ADDENDUM No. 1
BID DOCUMENTS FOR
MANCHESTER • BOSTON REGIONAL AIRPORT
PRE-CONDITIONED AIR UNITS & GROUND POWER EQUIPMENT REPLACEMENTS
PROJECT
MHT / City Bid # FY22-805-51
AIP # 3-33-0011-TBD-2022

May 6, 2022

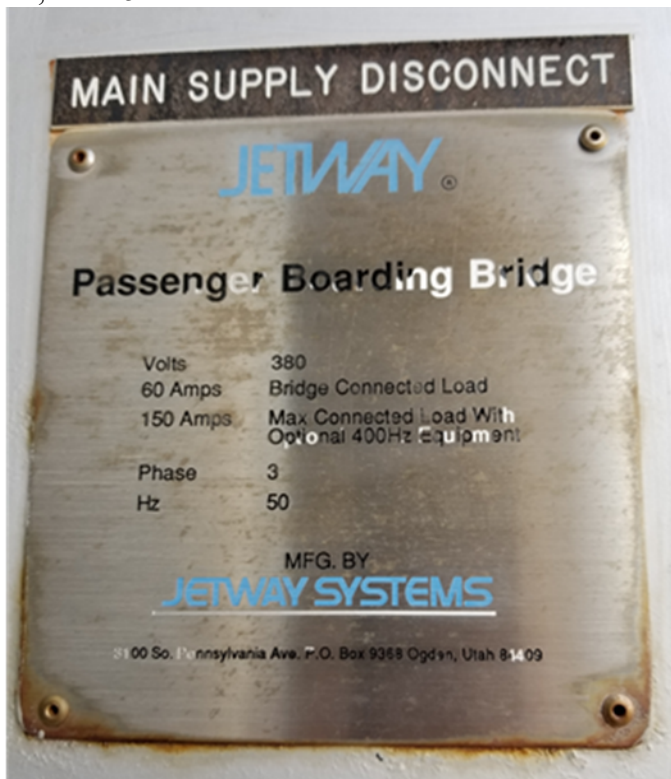
1. Revise Volume I - Bid Proposal & Contract, Specification Section 00030 Bid Advertisement and Specification Section 00100 Instruction To Bidders Subsection 1.25 ADDENDA AND INTERPRETATIONS to indicate the following:

All Bid-Related Inquiries shall be submitted in writing and received on or before 3:00 pm on Thursday May 19, 2022, to John G. Goudreault, P.E., Associate Vice President at AECOM, via email to john.goudreault@aecom.com.

Any and all such interpretations and any supplemental instructions will be in the form of written addenda to the specifications which, if issued, **will be emailed to the prospective bidders (at the respective email address furnished to the Airport for such purposes), not later than 5:00 pm on Friday May 20, 2022** and will subsequently be posted to the Airport's website at www.flymanchester.com.
